# Rerouting Decomposition Reactor Cooling Lines

# UPDATE

Blue Bird has new guidelines from Cummins for the installation of the after treatment decomposition reactor cooling lines that is intended to reduce the formation of crystalized DEF around the injector during a hot shut down. The changes can reduce down time and engine torque de-rates, and increase system reliability and customer satisfaction. Buses built prior to these new guidelines can receive the same benefits by updating the routing of the decomposition reactor cooling lines. This product improvement is not covered by the limited warranty.

Models affected: 2010-2014 Visions and All Americans with Cummins ISB, ISC, & ISL 2010/2013 emissions diesel engines built prior to May 27, 2013.

Fig. 1

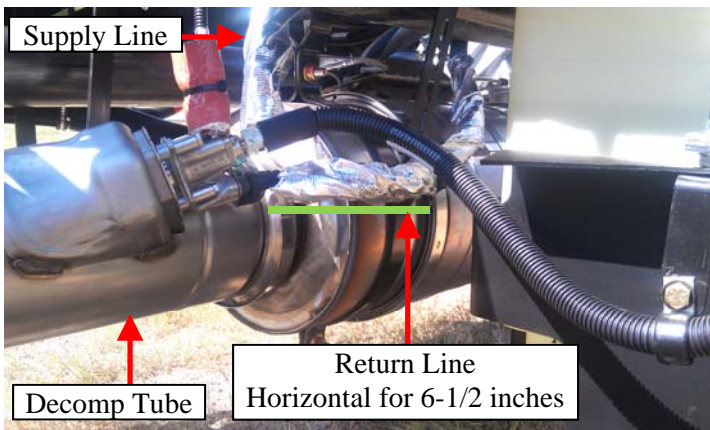
Visions require a new bracket, clamp, and fasteners that will move the coolant return line to a horizontal position for a minimum of 6-1/2 inches from the decomp tube as shown in figure 1. The bracket (10034335) will attach to the frame rail behind the DEF tank as shown in figure 2. See figure 3 for illustration of parts. The coolant supply line will remain in the vertical position.

Fig. 4

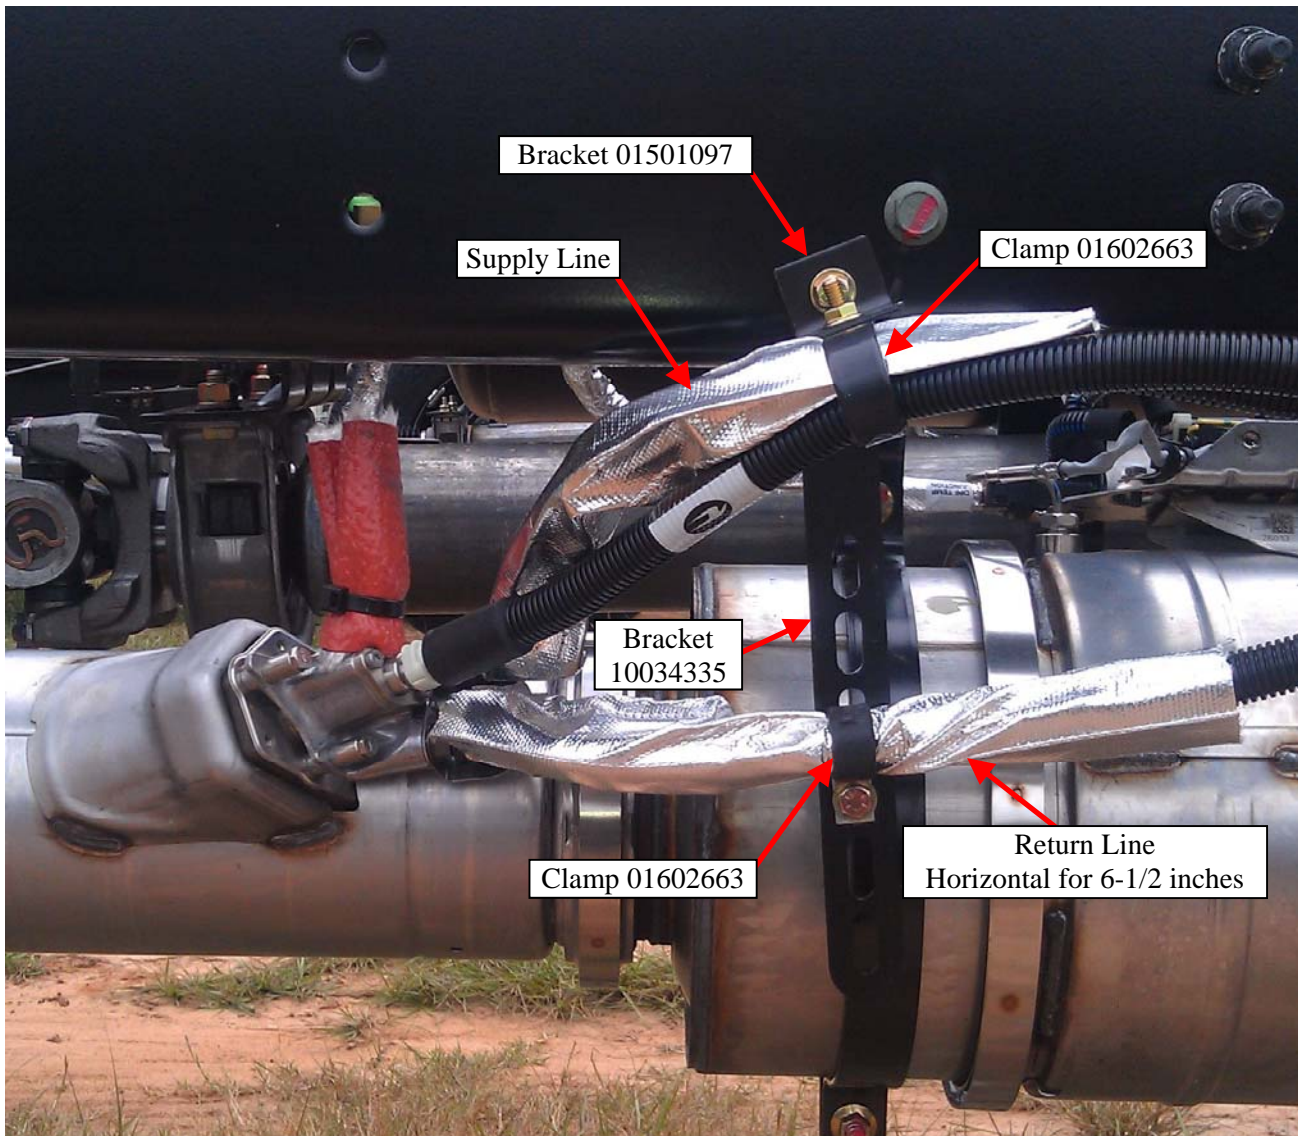
All American Front Engine buses with an in-line exhaust configuration require two brackets, two clamps, and fasteners that will move the coolant return line to a horizontal position for a minimum of 6-1/2 inches and the coolant supply line to vertical position as shown in figure 4. The bracket (10034335) will attach to an existing hole in the frame rail just in front of the decomposition tube. See figure 5 for illustration of parts.

Fig. 6

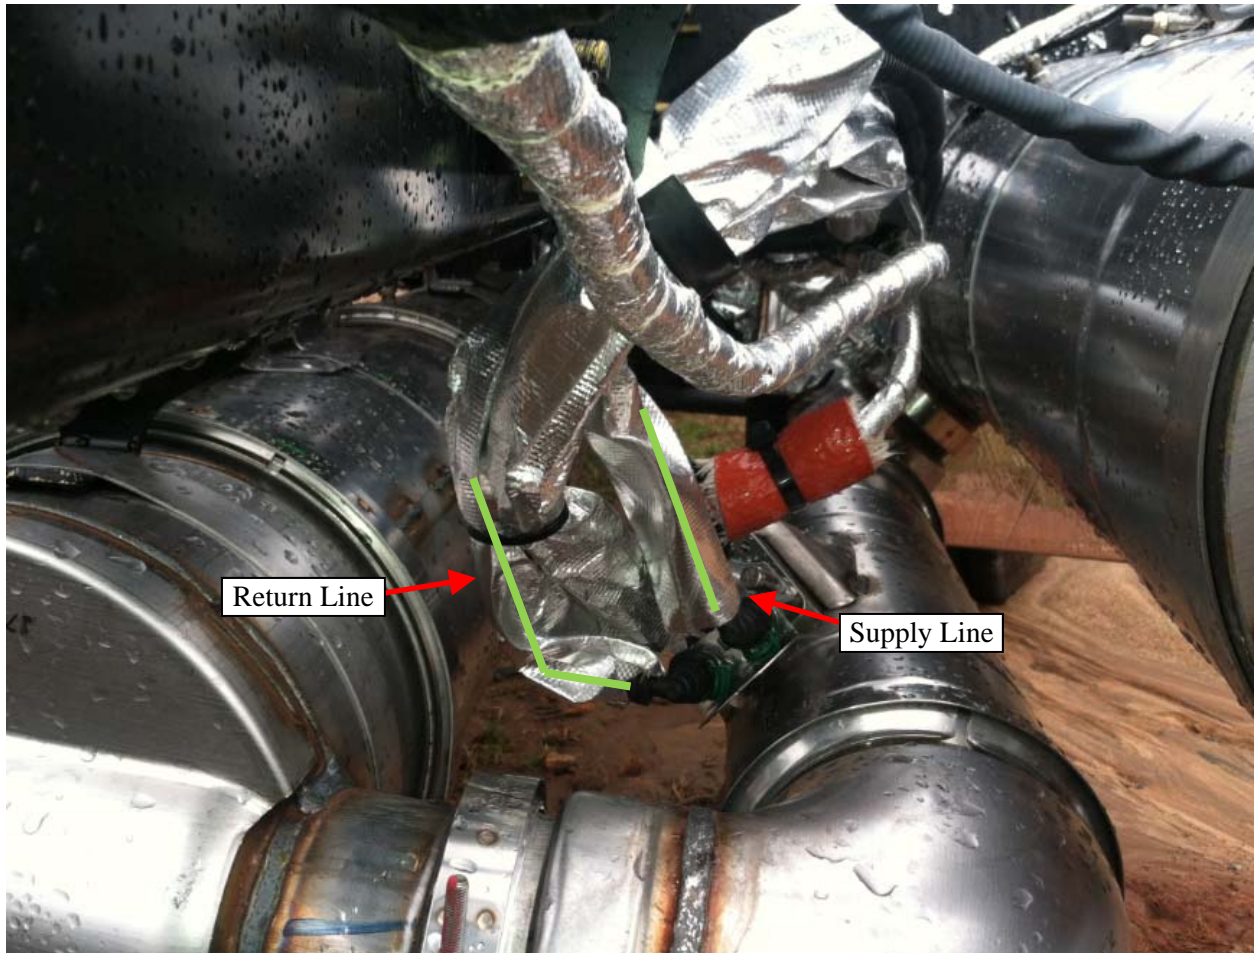
All American Front Engine buses with a switch-back exhaust configuration only requires a re-routing of the coolant supply line. The coolant supply line should remain in a vertical position. The coolant return line should exit horizontally before transitioning upward. See figure 6.

Fig. 7

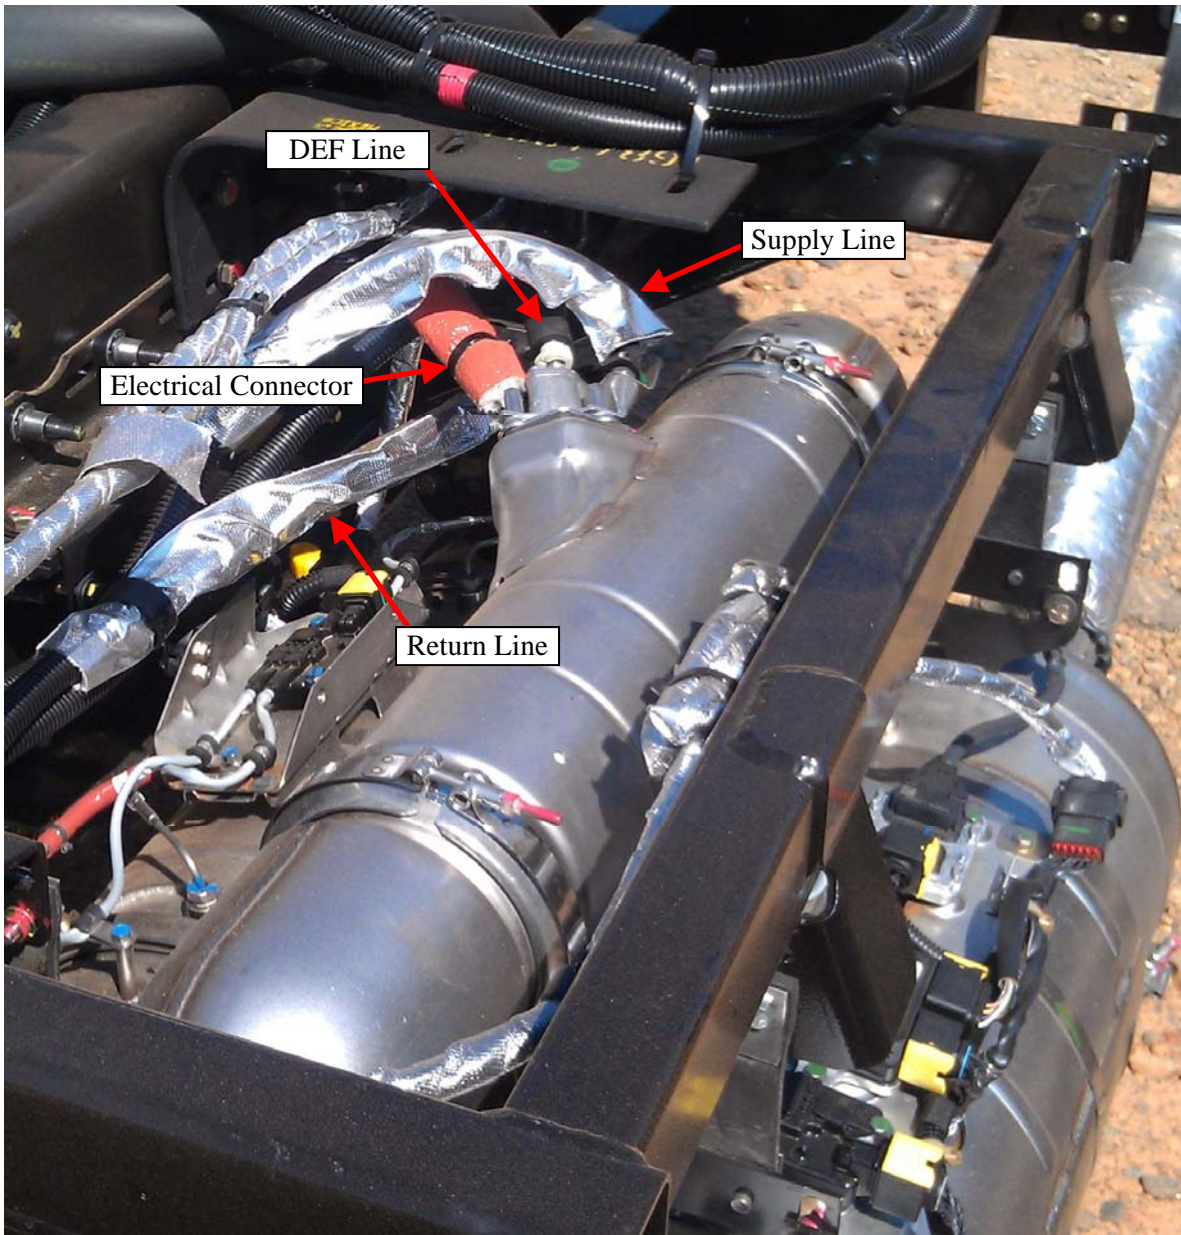
All American Rear Engine buses only require a re-routing of the coolant supply line. The coolant supply line should be re-routed so that it rises as high as possible over the coolant return line, DEF line, and the electrical connector. See figure 7.
